Kitchen Replacements at Lavery Lane Addendum #3; RFI's

This addendum modifies the contract documents prepared by The Delaware State Housing Authority, Inc. for this project and is incorporated into said documents in its entirety.

DWG 3/A201

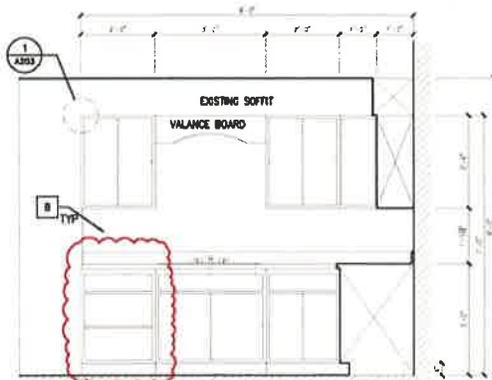
- AD 3.6. The pictures on the prints did not show a drawer base in the 3 bedroom apartments. Is a drawer base required? **YES, A DRAWER BASE IS REQUIRED. SEE REVISION TO DRAWING 3/A201 BELOW INDICATING LOCATION:**
